**CHARLES M. HINTON, JR. REGIONAL LANDFILL  
DALLAS COUNTY, TEXAS  
TCEQ PERMIT NO. MSW-1895A**

**PERMIT MODIFICATION**

**MONITORING WELL SPACING REVISION**

Re: Permit Modification Application  
Monitoring Well Spacing Revision  
Charles M. Hinton Jr. Regional Landfill, MSW Permit No. 1895A  
Dallas County, Texas  
Tracking No. 11994764; RN103049490/CN600328694

FIGURE 35

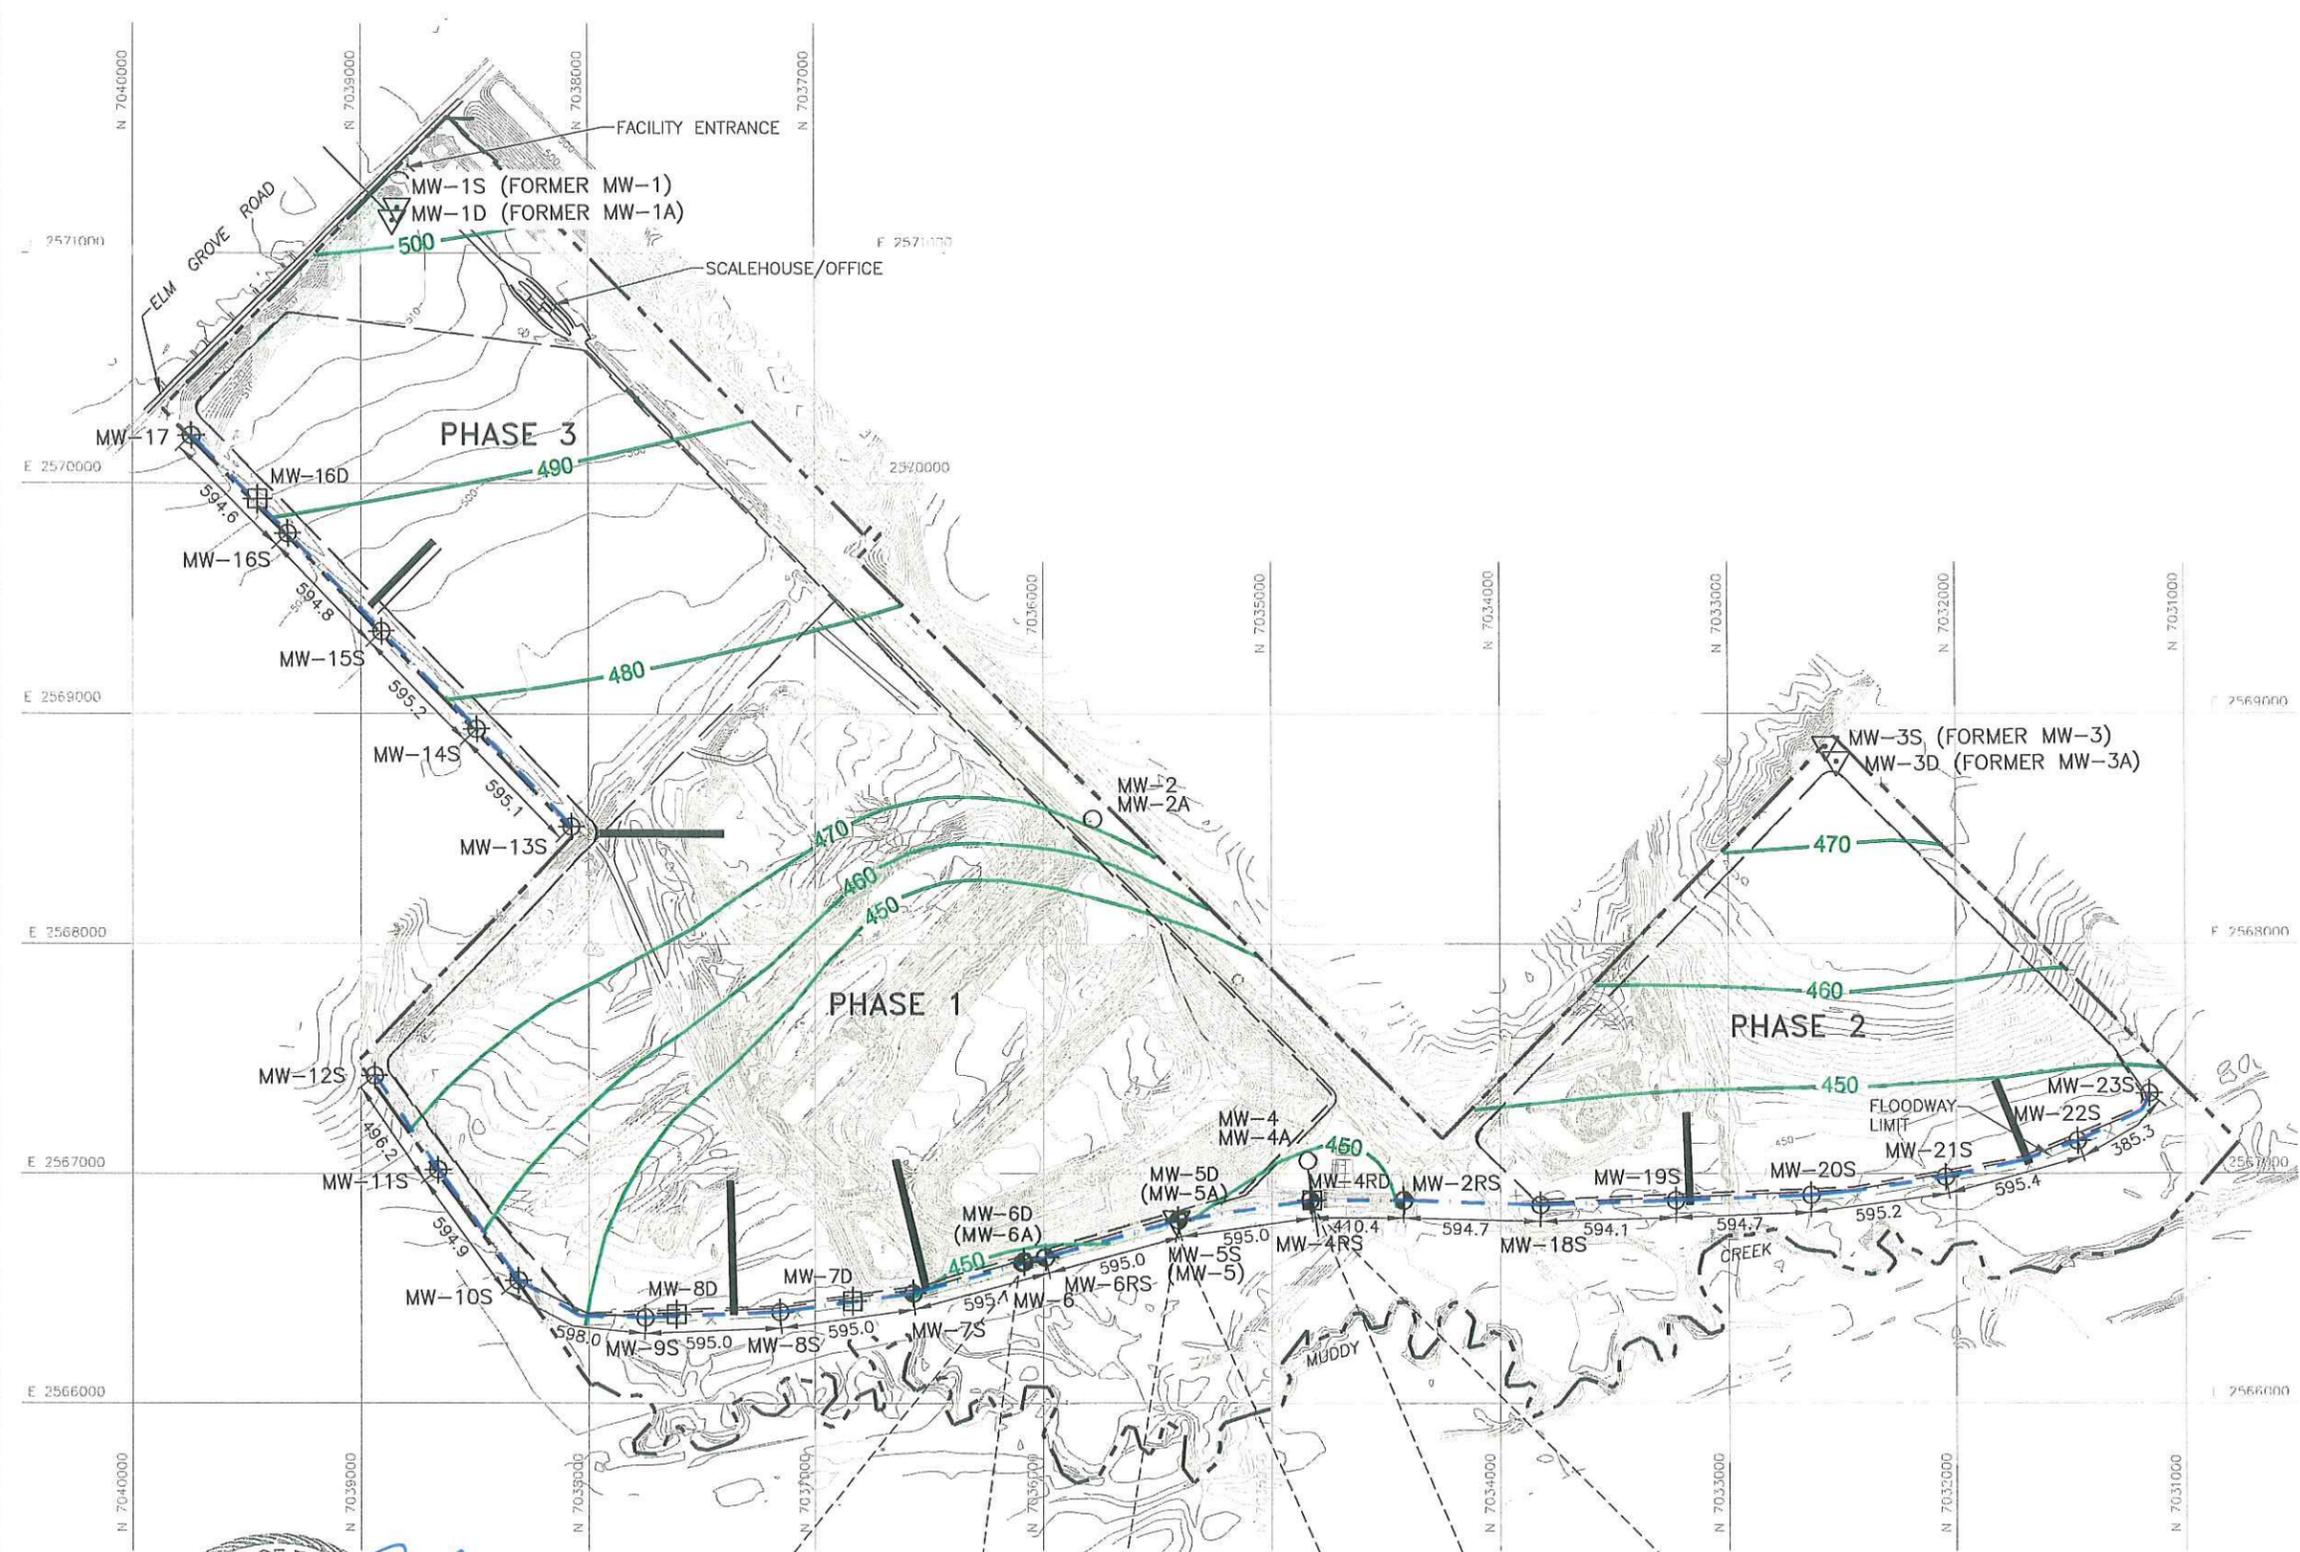
~~The proposed groundwater monitoring well system for this site will consist of twenty-four wells (MW-1, 2, 3, 4/4A, 5/5A, 6/6A, 7/7A, 8/8A, 9/9A, 10, 11, 12, 13, 14, 15, 16, and 17/17A). Wells MW-1 through MW-3 will be installed to monitor upgradient conditions and wells MW-4/4A, 5/5A, 6/6A, 7/7A, 8/8A, 9/9A, 10, 11, 12, and 13 will be installed to monitor downgradient conditions. The downgradient wells will be located by each sump, since these areas will contain the highest quantities of leachate. Wells MW-14 through MW-17/17A will be installed along the northwest perimeter of the proposed expansion area and will be located adjacent to the sumps for cell Nos. 21 through 24. Since the downgradient side of Phase 2 will be completed in the unweathered marl, cluster wells will be installed to monitor the alluvial terrace deposits and the unweathered marl. Therefore, the locations of MW-4 through MW-9 will consist of cluster wells. Wells designated with "A" will be completed in the unweathered marl. The locations of the proposed monitor wells are shown on Figure 35. A summary of the proposed well completion details is presented in Table 6. To keep the downgradient wells out of the floodplain and protect them from potential flooding, they will be installed in the levee embankment to be constructed on the west side of the landfill. In order to minimize the impact the levee will have on existing drainage patterns, it will be constructed in phases during the development of the landfill (refer to site development plan for sequence of development). Therefore, the downgradient monitor wells will be installed in phases as each stage of the levee is completed. The downgradient wells will be within 500 feet of the waste fill footprint.~~

As shown on Figures 35 and 36, the proposed monitoring system will consist of 31 monitoring wells when the landfill is fully developed. Four existing background detection monitoring wells (MW-1, MW-1A, MW-3 and MW-3A) are designated background well pairs in the proposed system. With the approval of this permit modification, these four wells will be renamed MW-1S, MW-1D, MW-3S, and MW-3D, respectively. The 'S' in the well name indicates the well is screened in a shallower portion of the uppermost aquifer and the 'D' indicates the well is screened in a deeper portion of the uppermost aquifer. One existing background well pair (MW-2 and MW-2A) will be removed at the time of new well installations – as only two sets of background wells are needed for statistical evaluation purposes.

<b>FIGURE 37</b>

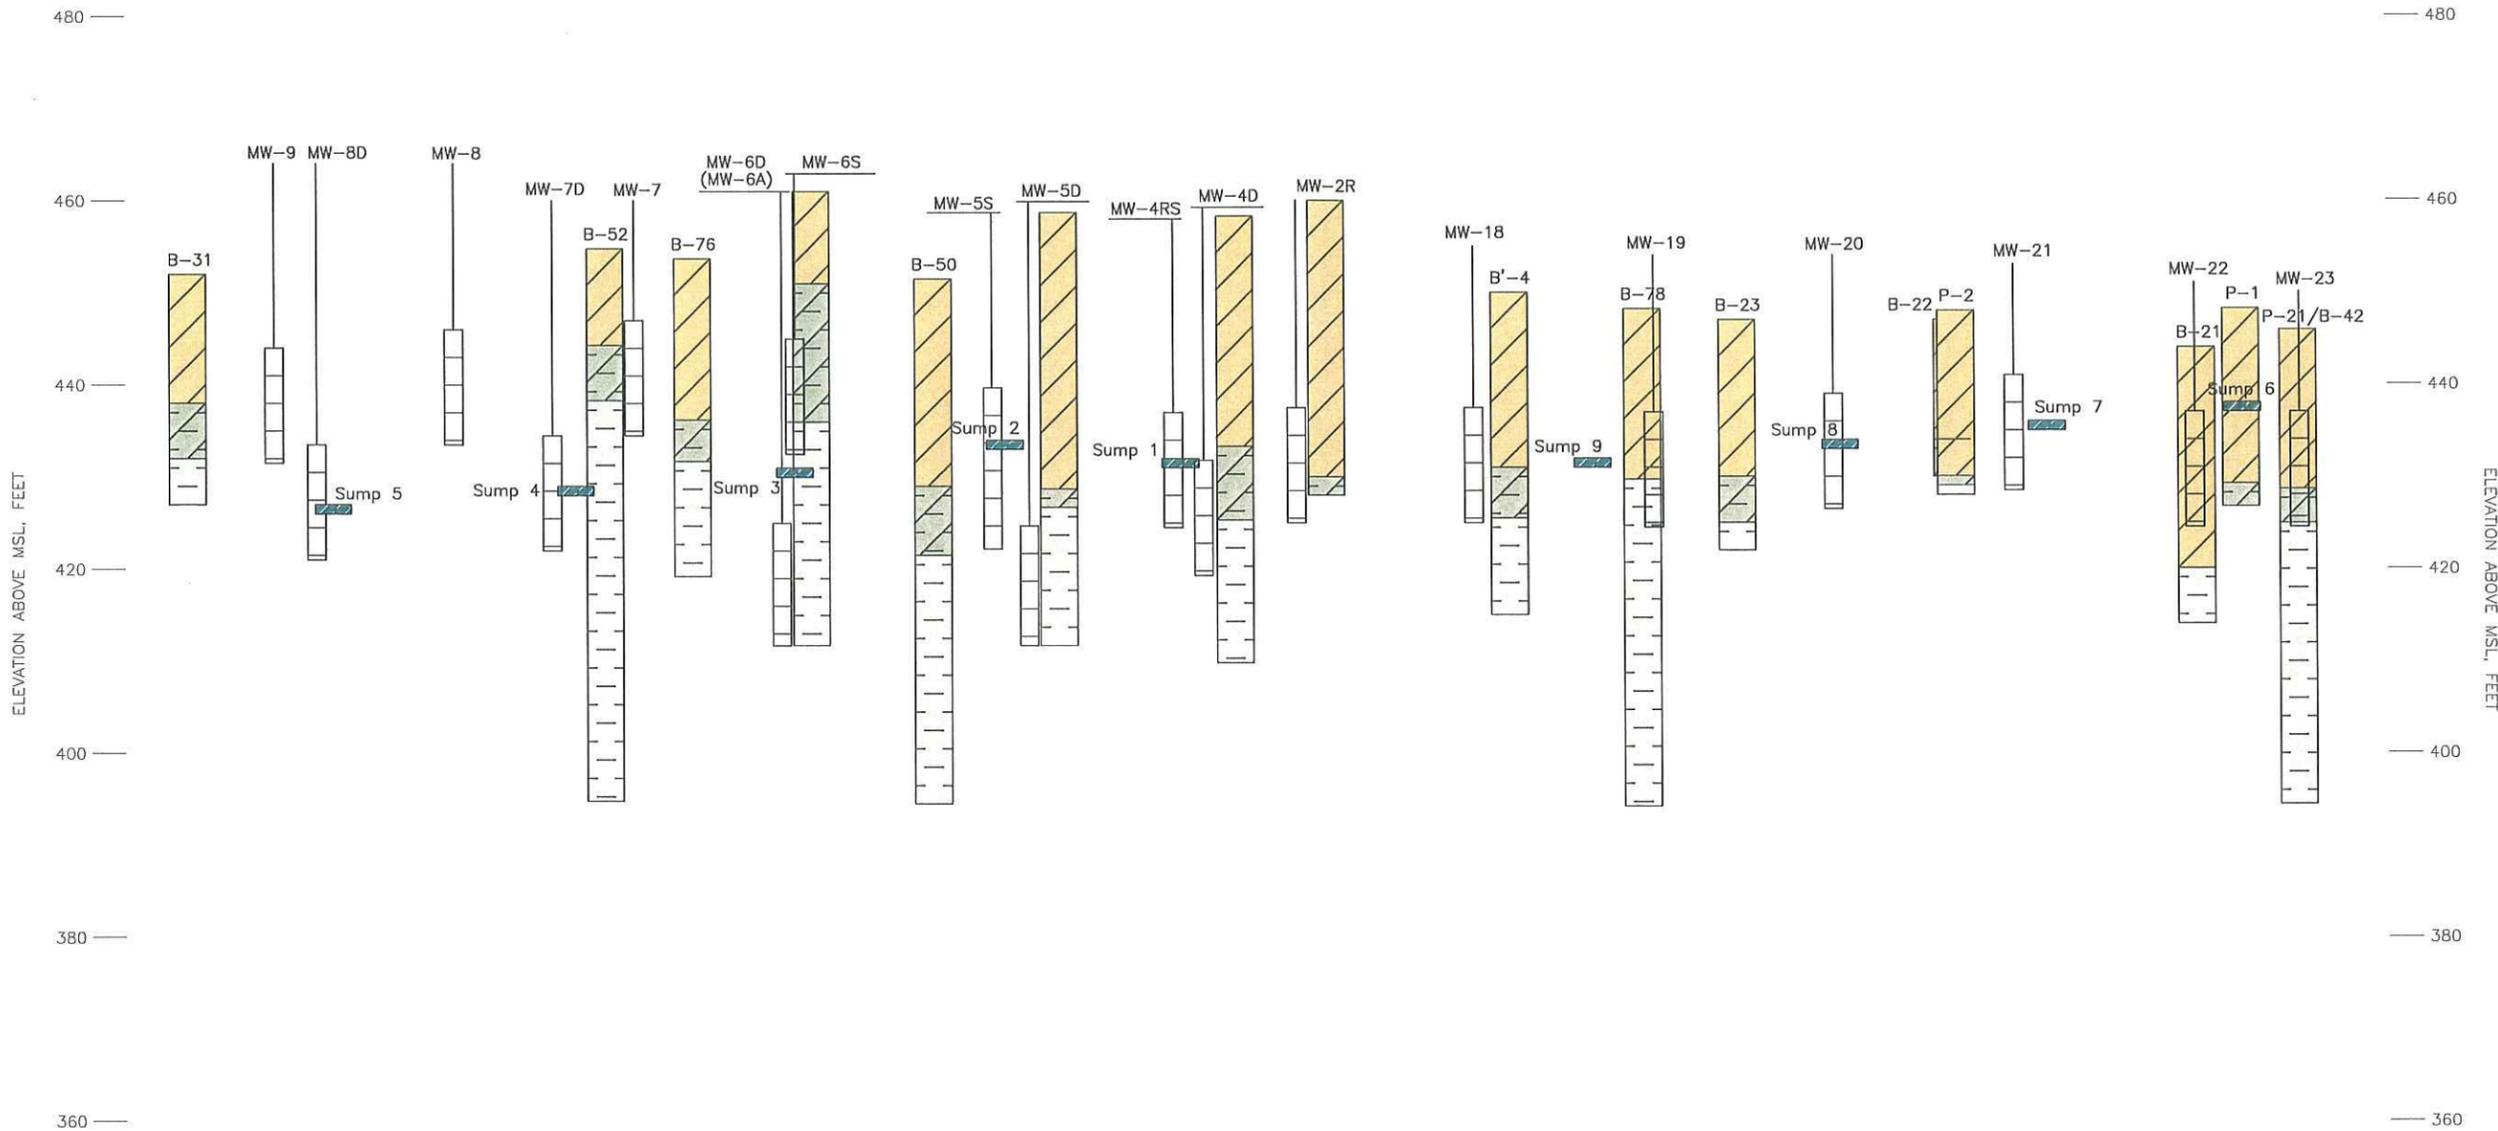
Replacement or Additional Page/Section Number	Explanation
Attachment 4 – Cover Page and Table of Contents	Pages have been signed and sealed for updated SDP.
Attachment 4 – Section 7	Pages updated to include revised groundwater monitoring system. Former Section 7 well construction details table information (pages 75 and 76) has been moved and updated as Figure 36 in Appendix A. Also updated proposed Section 7 well construction text to present industry standards.
Attachment 4 – Appendix A, Figure 35	Former Figure 35 – Proposed Groundwater Monitoring System replaced with proposed Figure 35 to reflect revised groundwater monitoring system layout.
Attachment 4 – Appendix A, Figure 36	Former monitor well details table on pages 75 and 76 removed and replaced by Attachment 4's Appendix A, Figure 36 – Proposed Monitoring Well Details to reflect revised groundwater monitoring well details.
Attachment 4 – Appendix A, Figure 37	New Figure 37 – Final Western Point of Compliance geologic cross section added to illustrate proposed groundwater monitoring system configuration on the west side of the landfill.

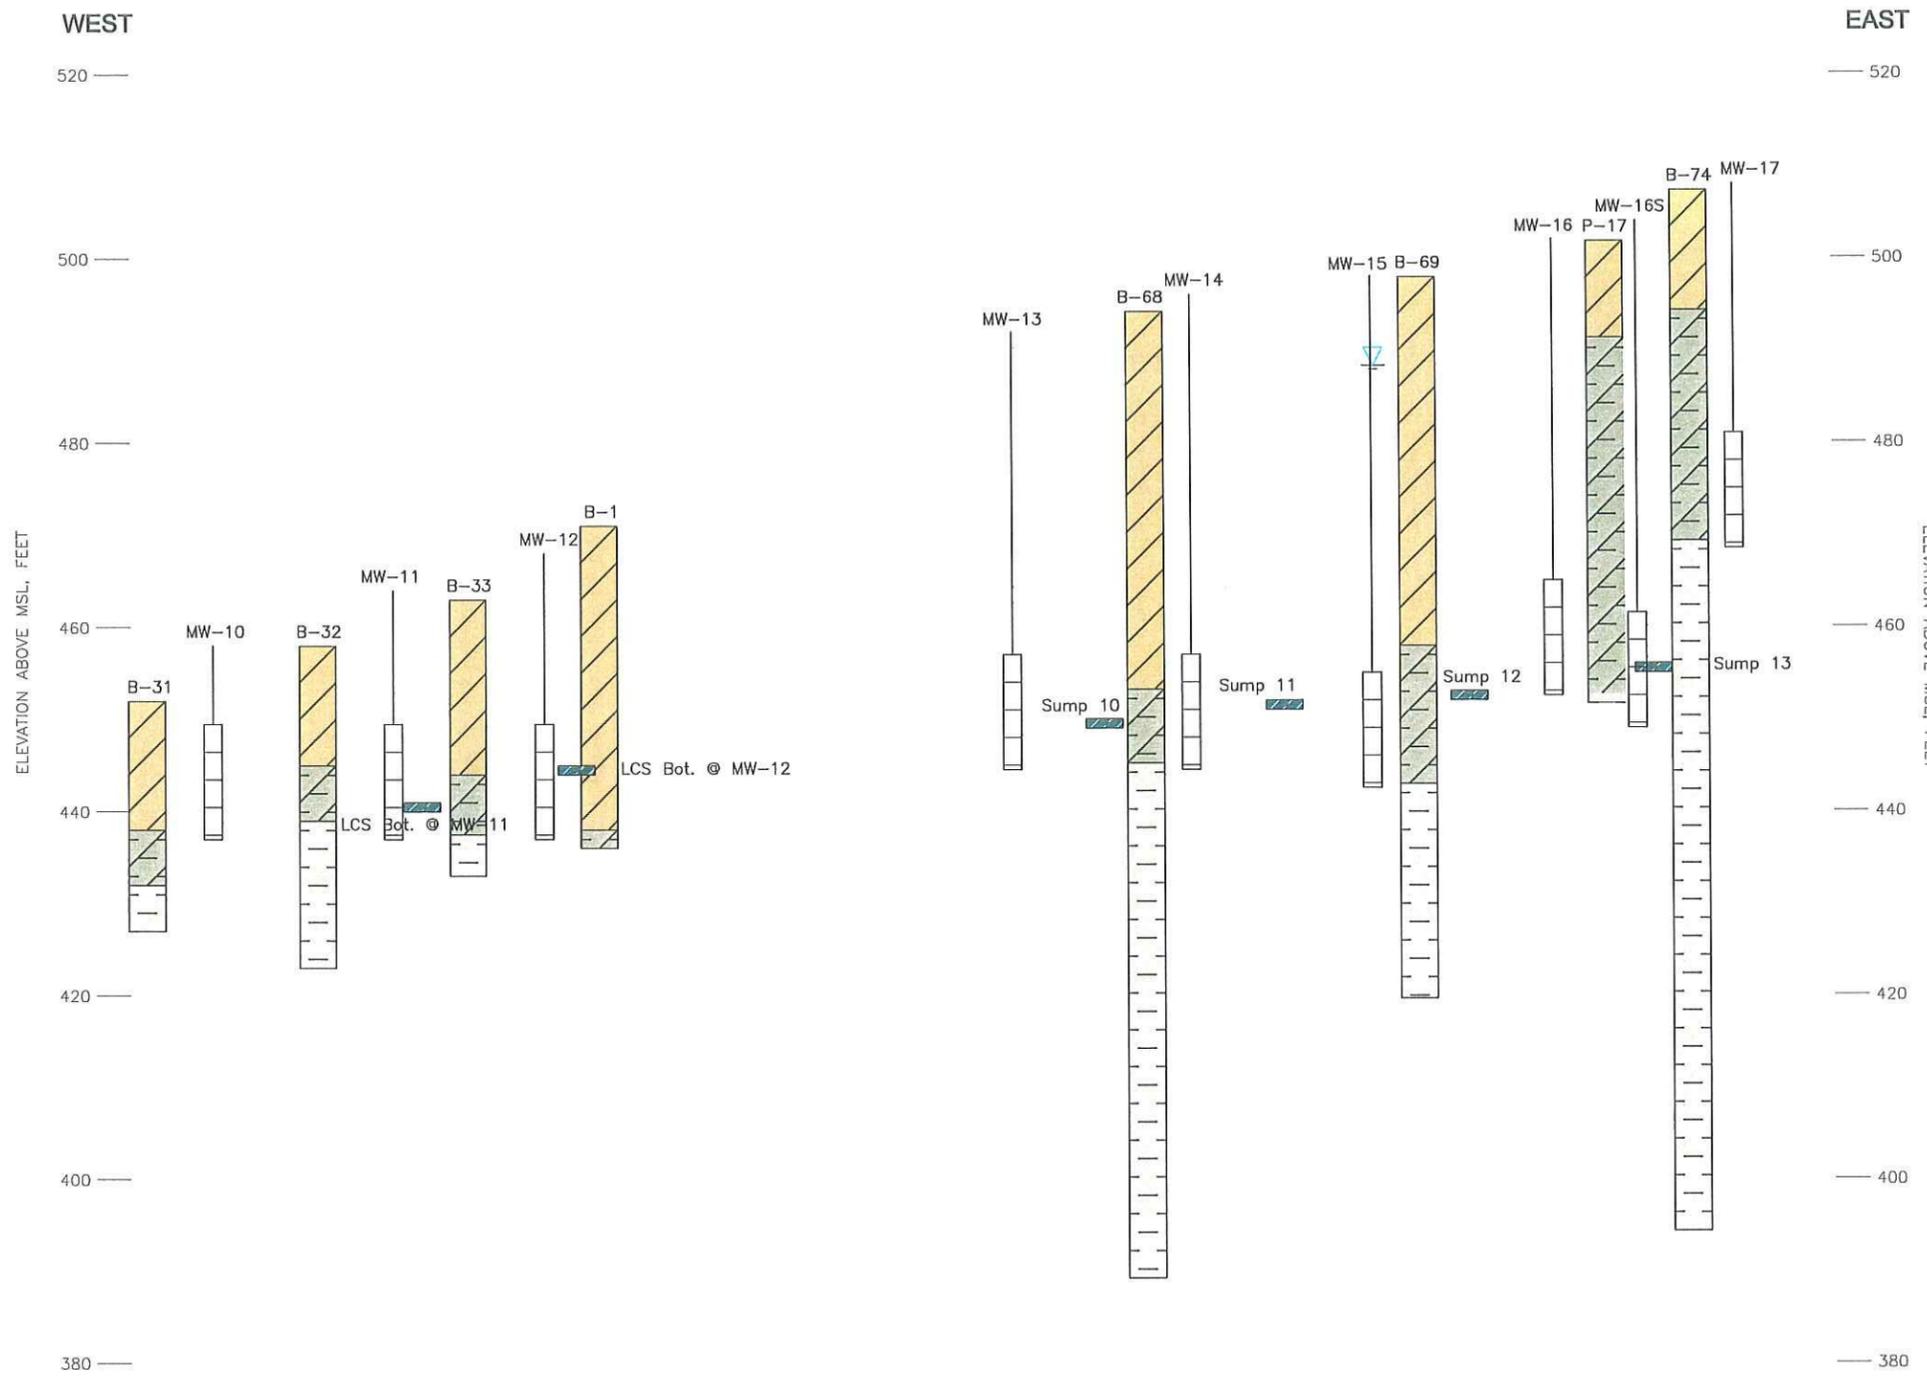
Attachment 4 – Appendix A, Figure 38	New Figure 38 – Final Northern Point of Compliance geologic cross section added to illustrate proposed groundwater monitoring system configuration on the north side of the landfill.
Attachment 5 – Cover Page and Table of Contents	Pages have been signed and sealed for updated SDP.
Attachment 5 – Section 3.5	Pages updated to include revised groundwater monitoring system. Former Section 3.5 well construction details table information has been moved and updated as Figure 14 in Appendix A of Attachment 5. Also updated proposed well construction text to present industry standards.
